GOVERNMENT OF THE DISTRICT OF COLUMBIA
OFFICE OF PLANNING

MEMORANDUM

CASE NO. 17679

SUBJECT: BZA 17679 - Takoma Park
6923-6953 Maple Street, NW and 6916-6926 Willow Street, NW
Square 3357, Lots 26-29, 40, 808, 811, 814, 815, 818-820, 824, 825, 840, and 843

Figure L
Priority Redevelopment Sites

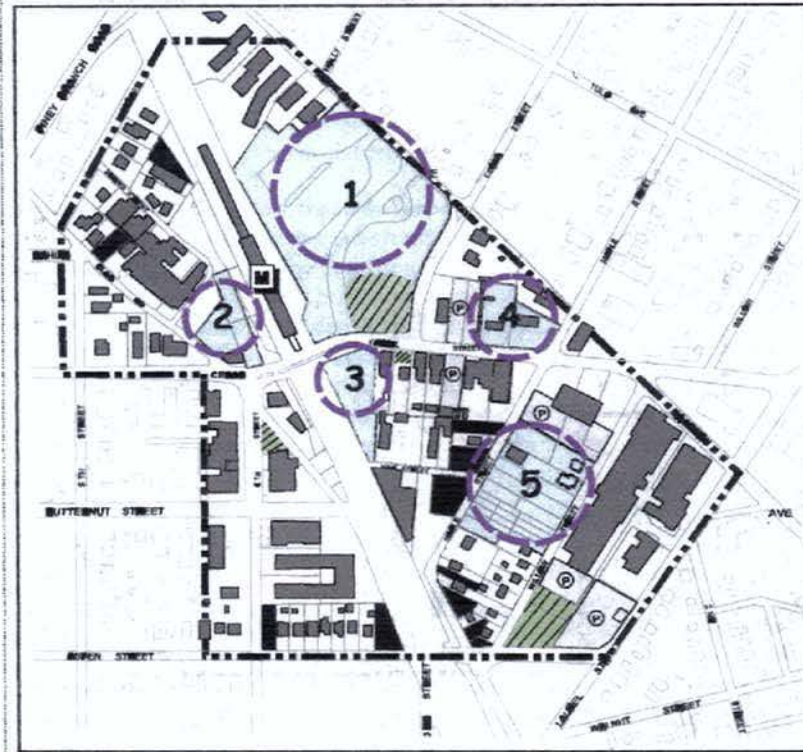
The Plan further recommends that within the Opportunity Sites there are a number of sites that are identified as ***Priority Redevelopment Sites***. These sites are to be the focus of initial efforts to attract near-term investments in the Central District. The development mix is based on the existing zoning, proposed projects, and preferred scale and intensity recommended in the Plan. It is envisioned that the sites could yield up to 305 housing units. The subject site is identified as ***Priority Redevelopment Site5*** and is recommended for garden apartments or townhouses (Figure L).
